FINAL DRAINAGE REPORT ADDENDUM

SUNSET VILLAGE FILING NO. 4

PCD File No. CDR-218

December 3, 2021

DETENTION BASIN STAGE-STORAGE TABLE BUILDER

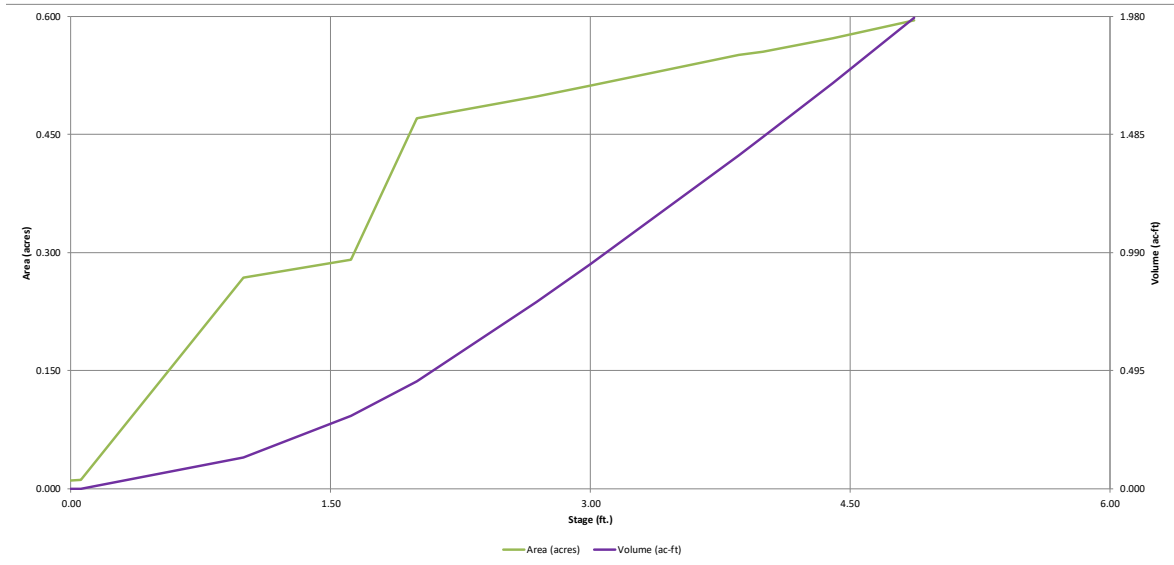
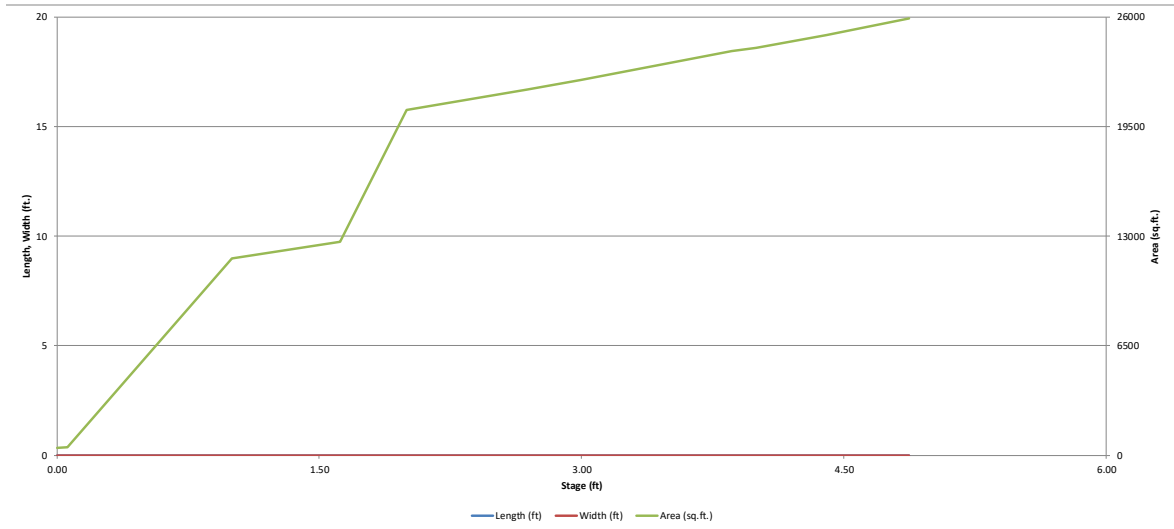
Include other EDB component sizing calcs, specifically for the forebay and trash rack.

DETENTION BASIN OUTLET STRUCTURE DESIGN

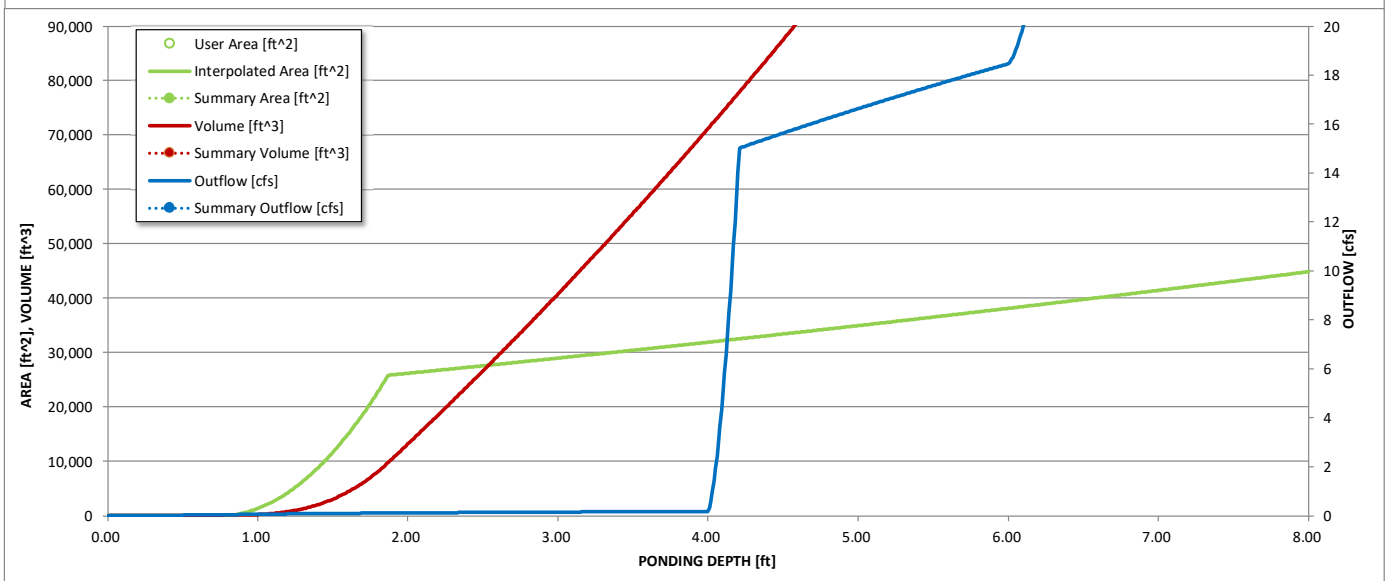
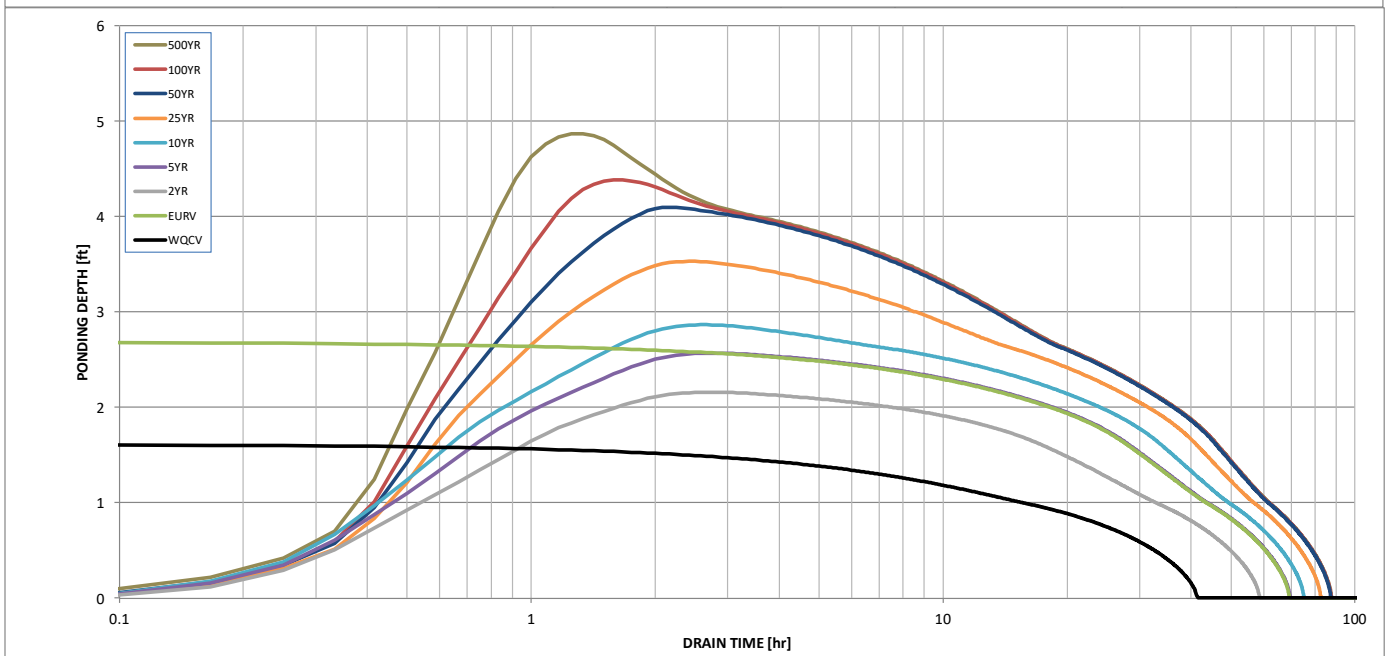
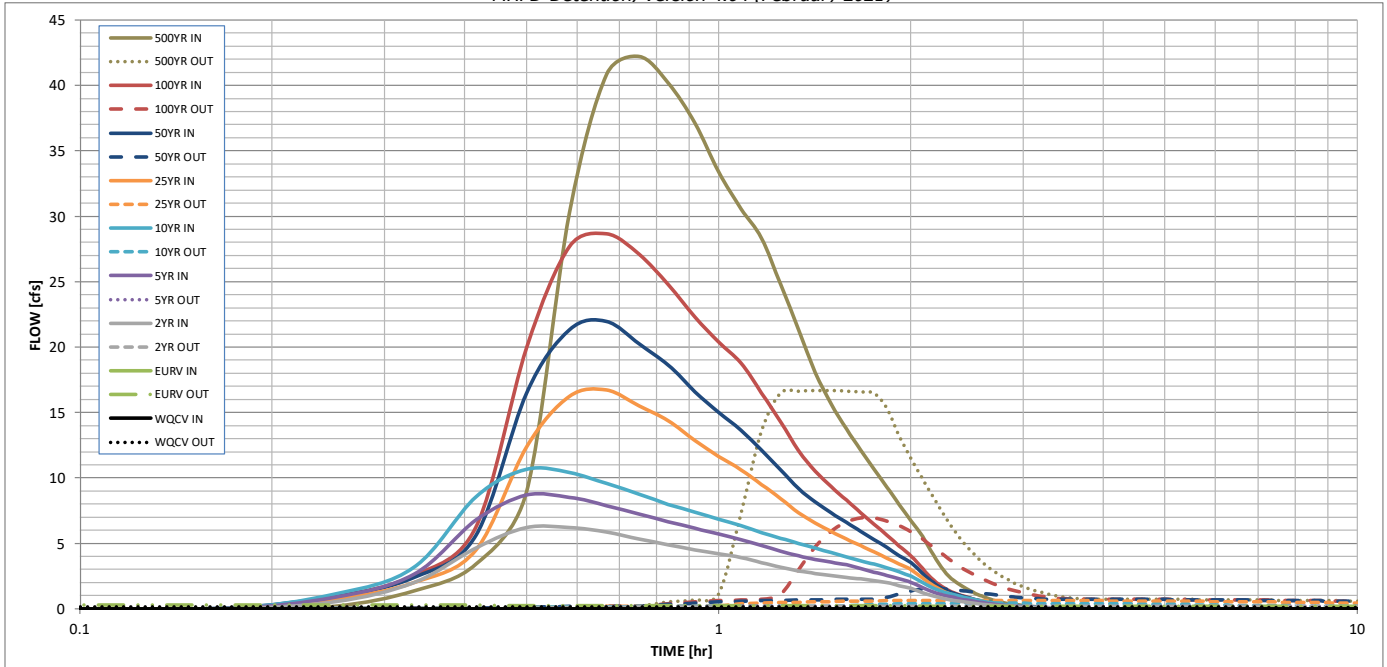
Revise Weir length to 3'
